### APPEAL SUMMARY

<b>Appeal ID:</b> 18796	<b>Project Address:</b> 901 SW King Ave
<b>Hearing Date:</b> 12/19/18	<b>Appellant Name:</b> Melissa Wortman
<b>Case No.:</b> B-020	<b>Appellant Phone:</b> 5032211121
<b>Appeal Type:</b> Building	<b>Plans Examiner/Inspector:</b> Maureen McCafferty
<b>Project Type:</b> commercial	<b>Stories:</b> 12 <b>Occupancy:</b> A-2, B, R-2, S-1 <b>Construction Type:</b> I-A
<b>Building/Business Name:</b> Celio Apartments	<b>Fire Sprinklers:</b> Yes - At Leasing Office and Vestibule Only
<b>Appeal Involves:</b> Alteration of an existing structure	<b>LUR or Permit Application No.:</b> 18-252048-CO
<b>Plan Submitted Option:</b> pdf [File 1]	<b>Proposed use:</b> Multifamily - Mailroom

# CELIO APARTMENTS MAILROOM RENOVATION

**CS**  
PERMIT SET

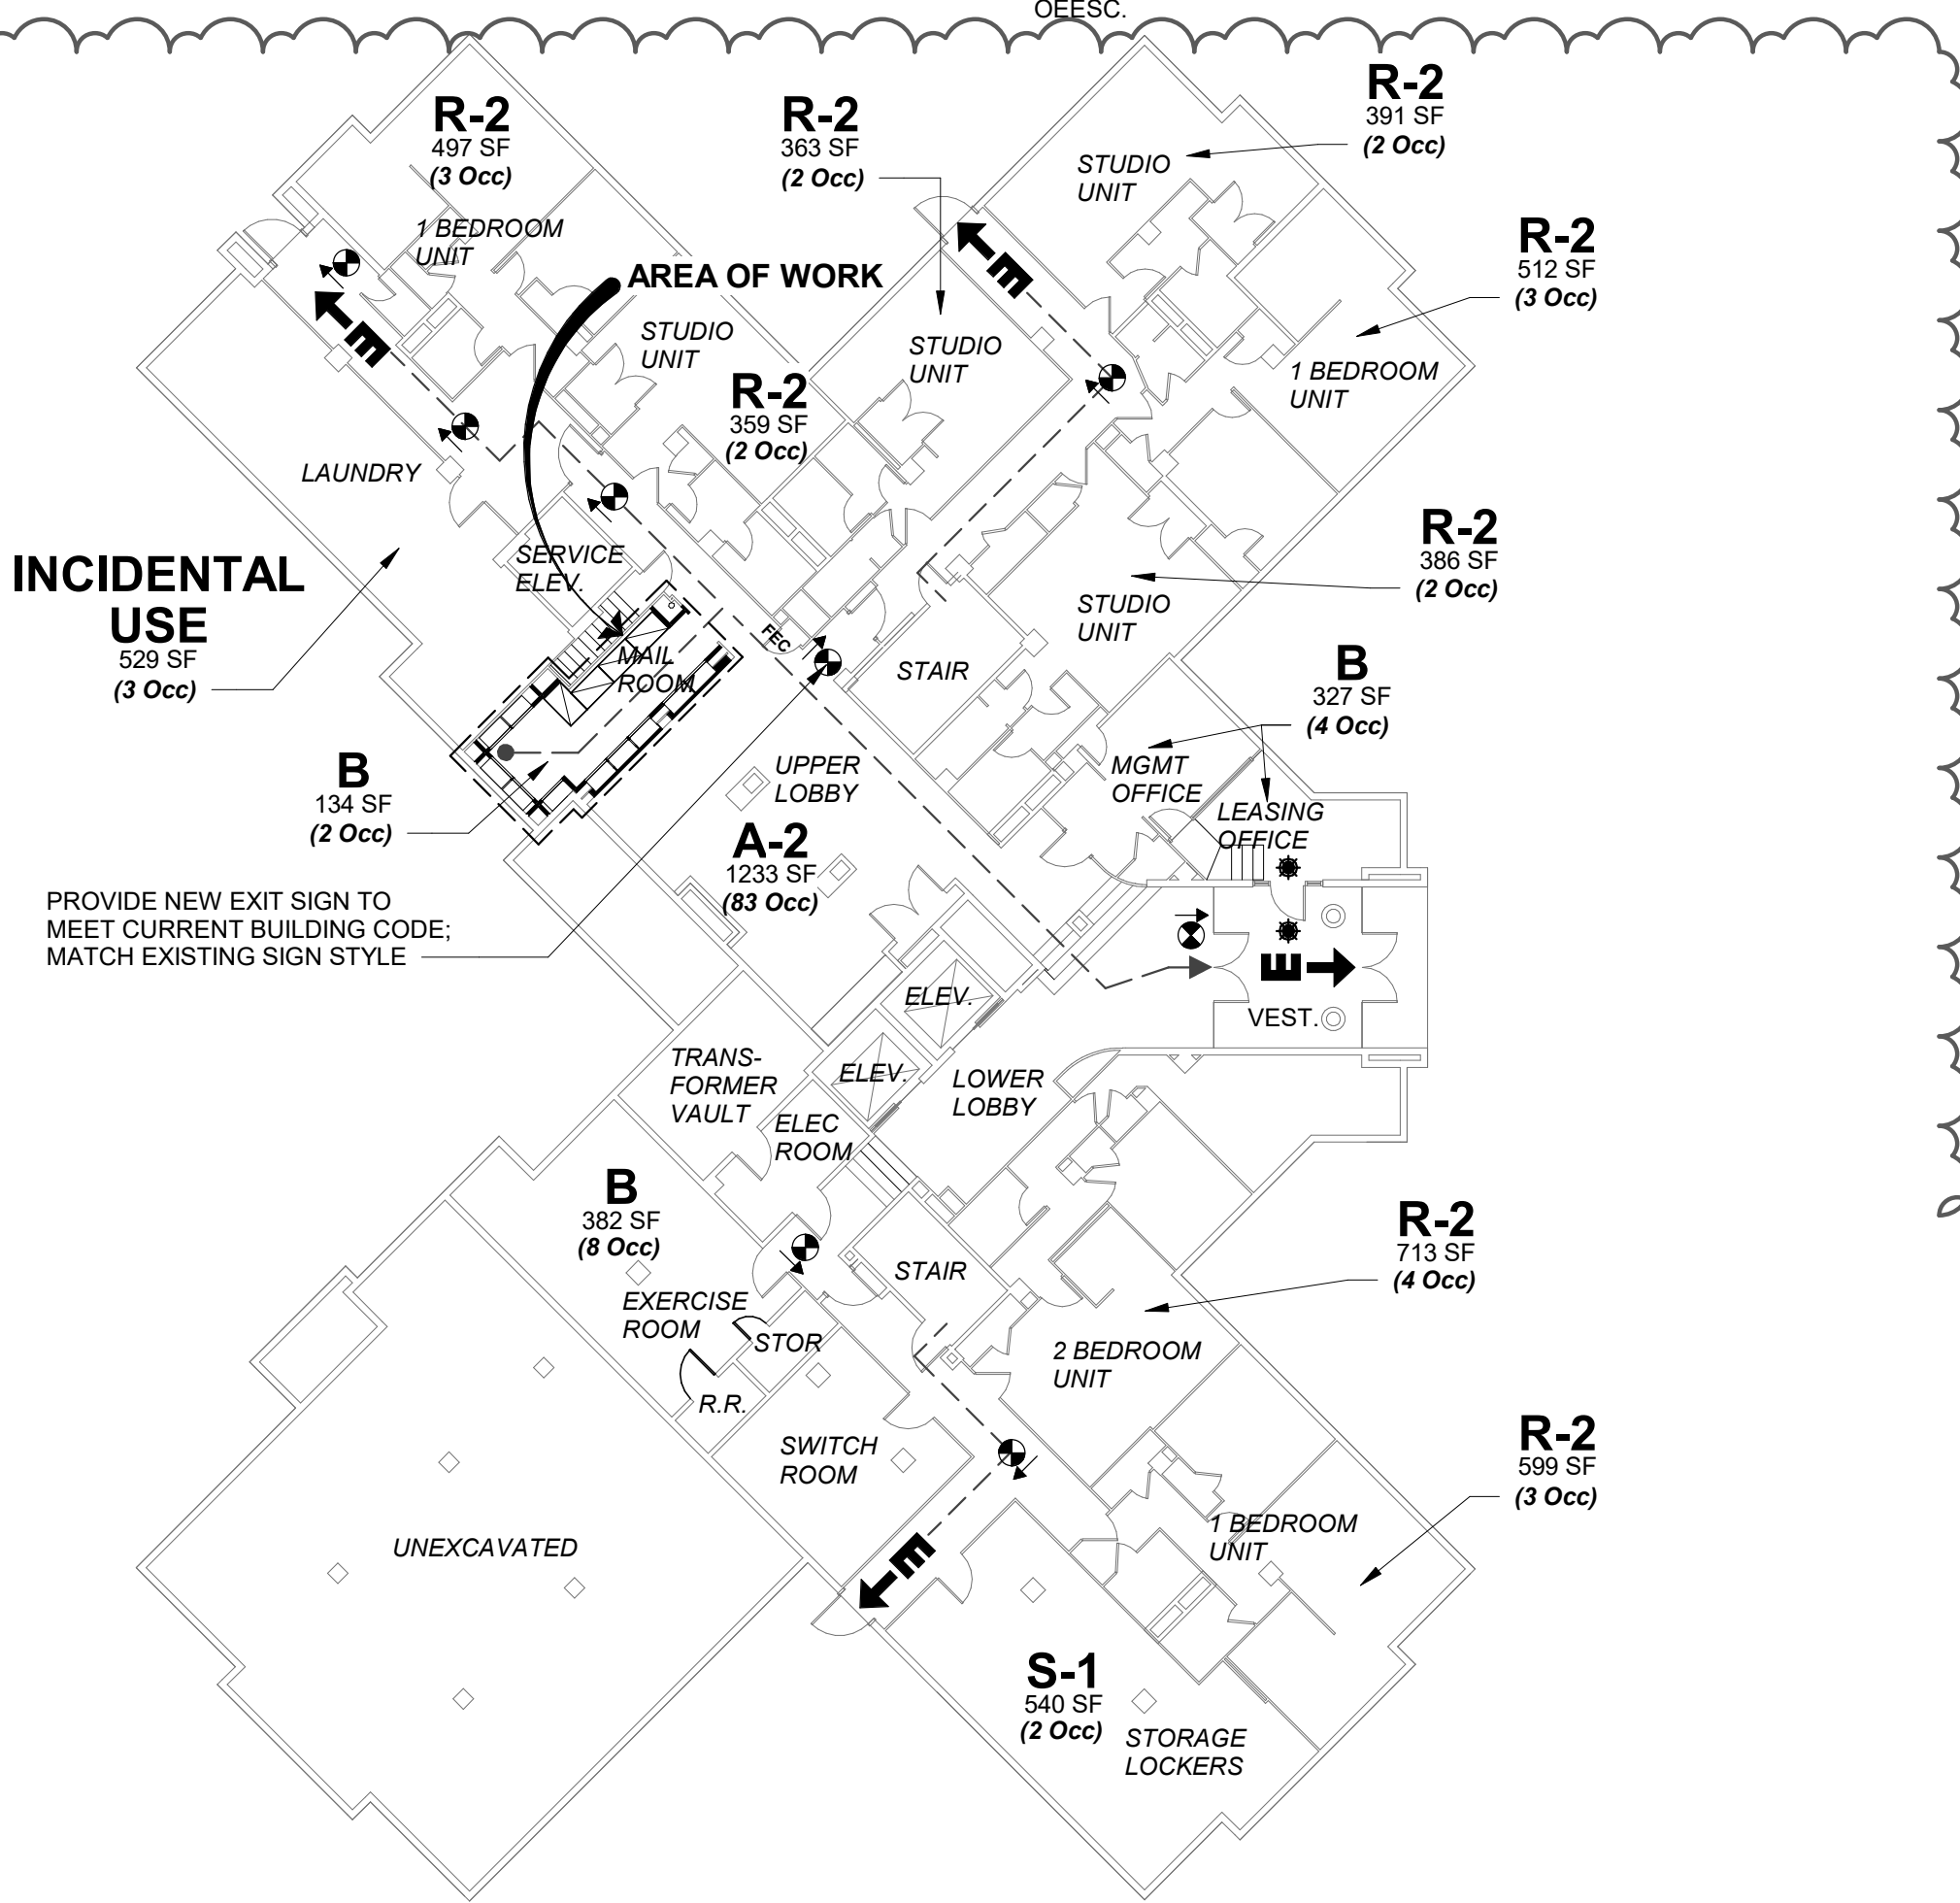
dwelling units are separated from this area via fire-protected doors. Those remaining two units are separated via existing rated party walls which meet the requirements for separation from other occupancies in section 420.2. Refer to Coversheet CS and Sheet A101 for the enclosed area and the location of existing fire-protected doors.

**Removal of fire rated mail room door: Granted as proposed.**

SHEET:  
**A101**  
PERMIT SET

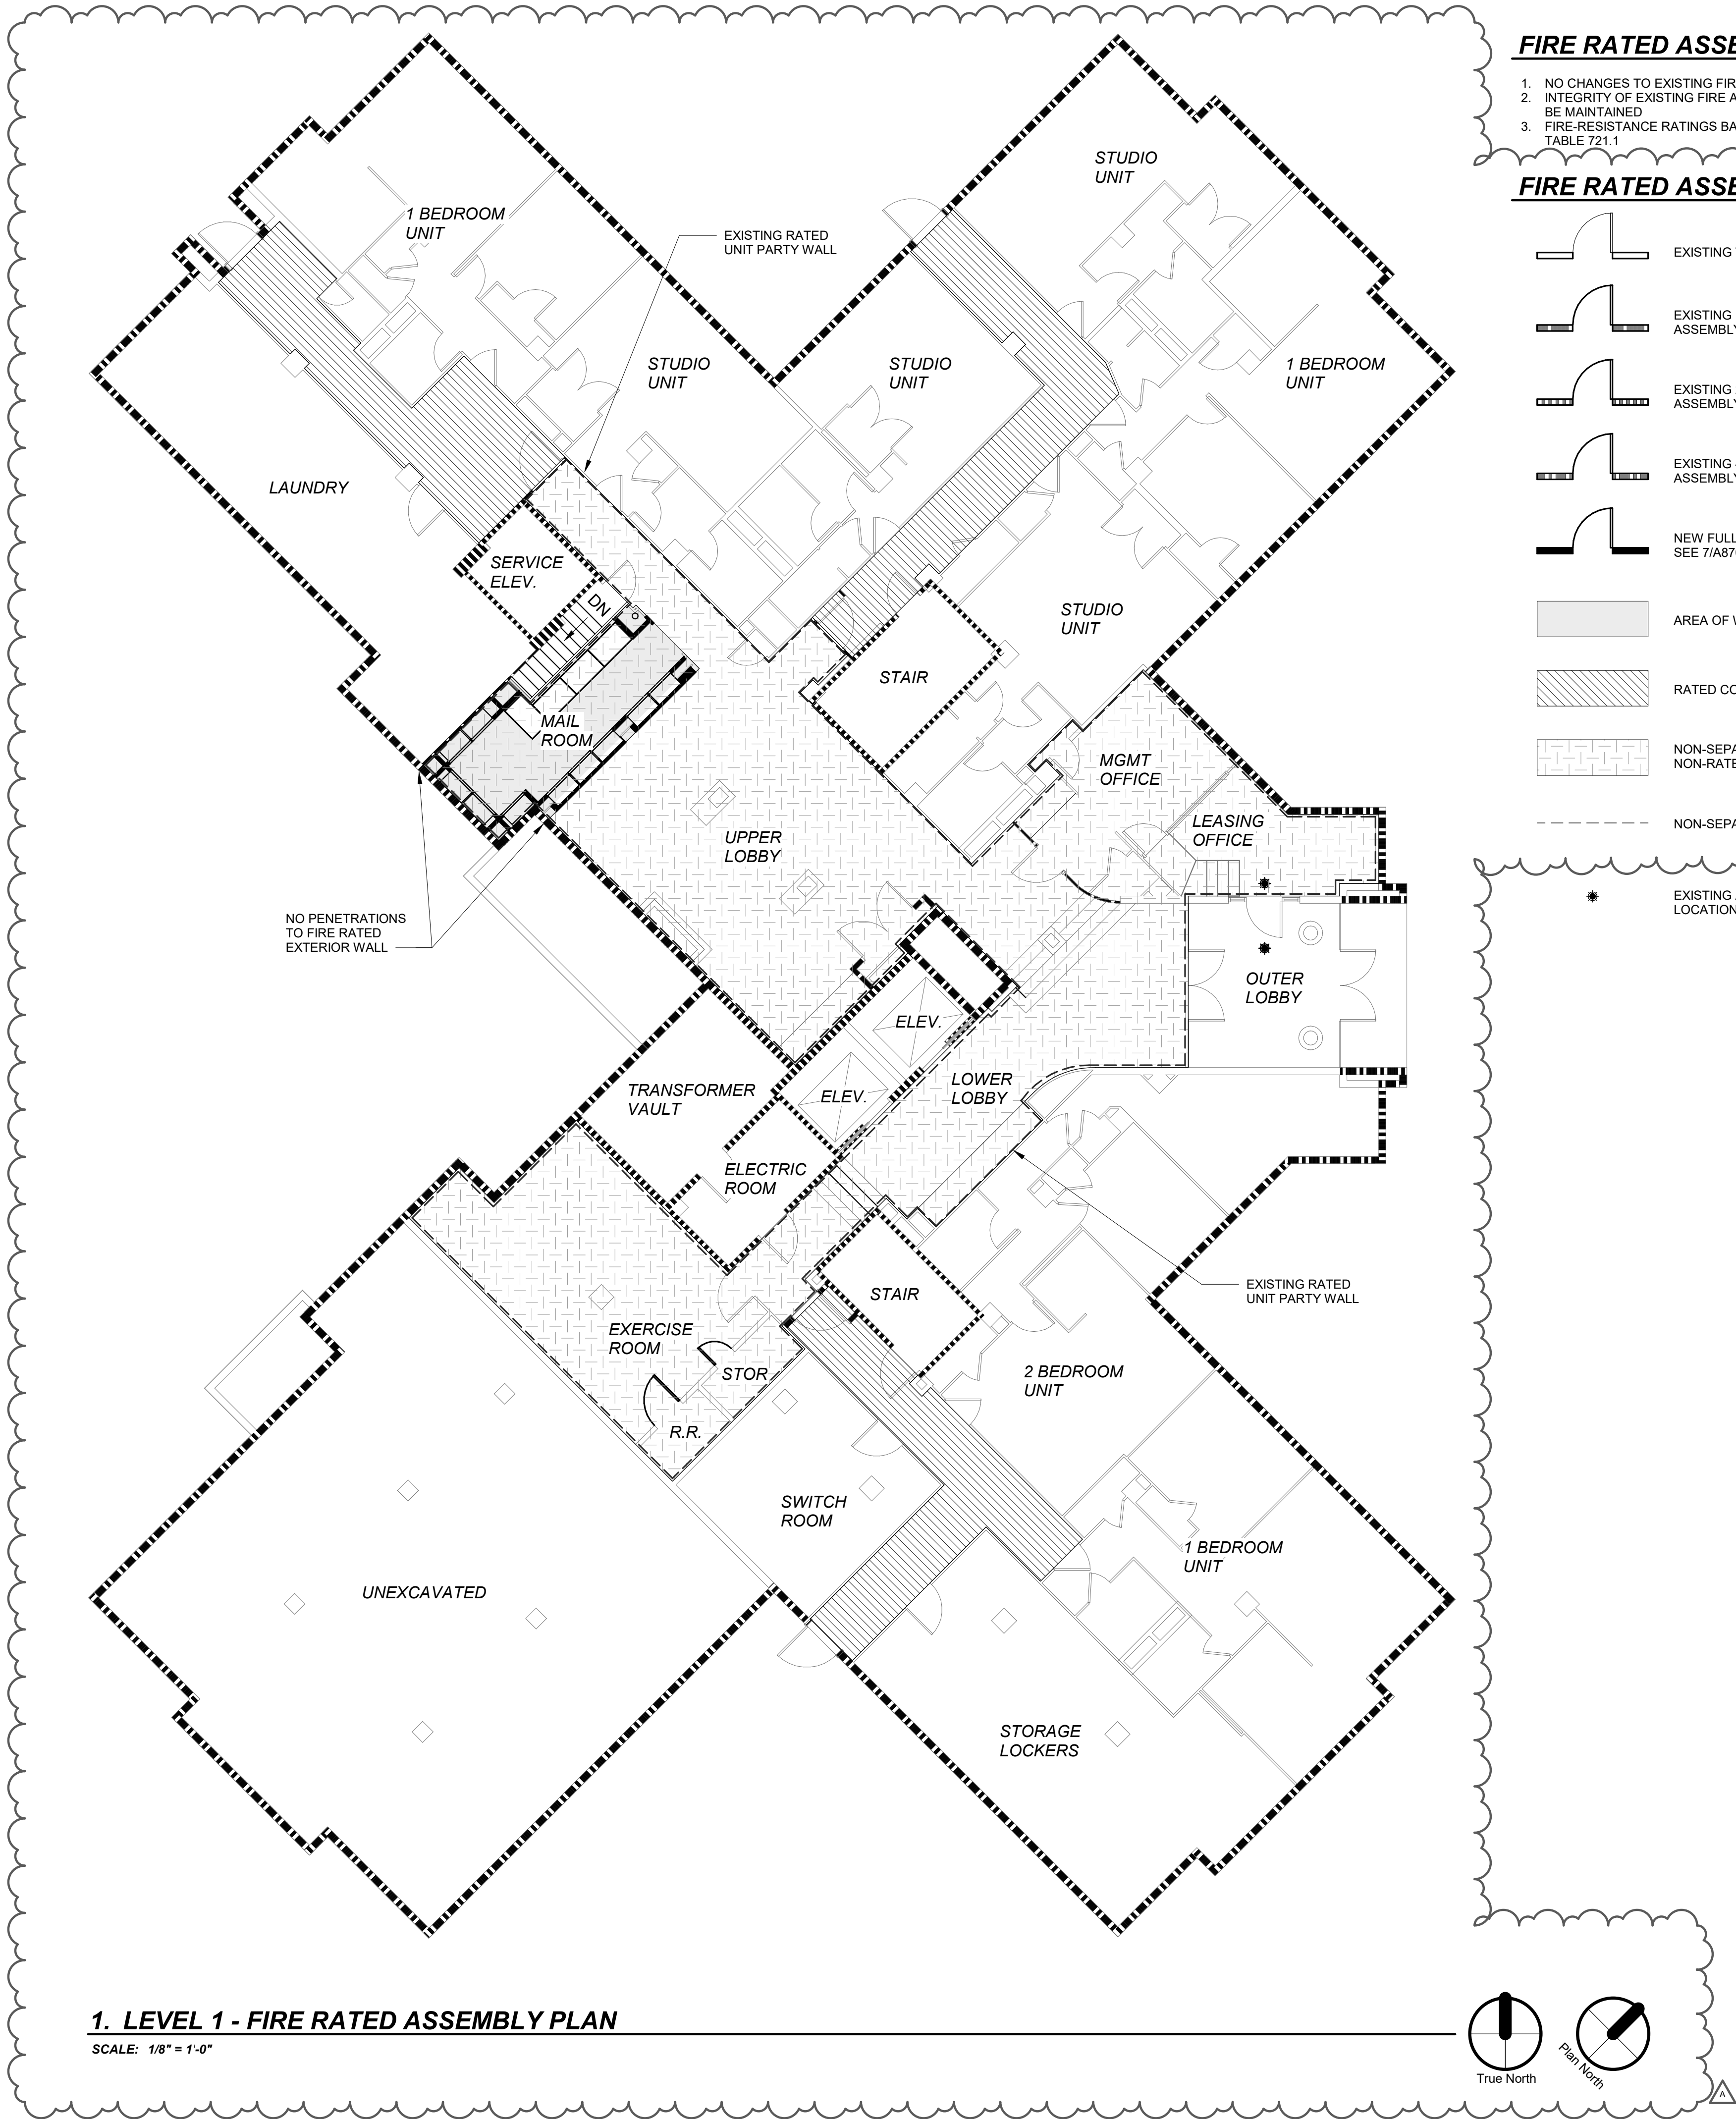
In reference to Section 1018.1 Construction, individual corridors in question are not fire-resistance rated in accordance with Table 1018.1 because the entire perimeter of the space within which they reside provides the required rating per Section 508.3 Non-separated Occupancies. This can be seen on Sheet A101. Please note the Fire Rated Assembly Legend showing the region which indicates "non-separated use with non-rated corridor" all within the rated boundary.

In reference to Sections 708.6 Openings and 716.5.3 Door Assemblies in corridors and smoke barriers, all openings and fire door assemblies in question lie within the constraints of the perimeter rated non-separated use space described above. This can be seen on Sheet A101.

Therefore, the proposed design removes an ineffective fire-protected door from an existing corridor to an existing mailroom. As described above, these non-separated occupancy spaces maintain the required fire ratings through the perimeter rated walls as seen with the rated wall designations on Sheet A101. Because these spaces all reside within the larger non-separated rated space, fire-protected doors between them are not required. Furthermore, per Table 503, I-A construction permits unlimited area for all of the occupancies contained within this area. All but two

The Administrative Appeal Board finds that the information submitted by the appellant demonstrates that the approved modifications or alternate methods are consistent with the intent of the code; do not lessen health, safety, accessibility, life, fire safety or structural requirements; and that special conditions unique to this project make strict application of those code sections impractical.
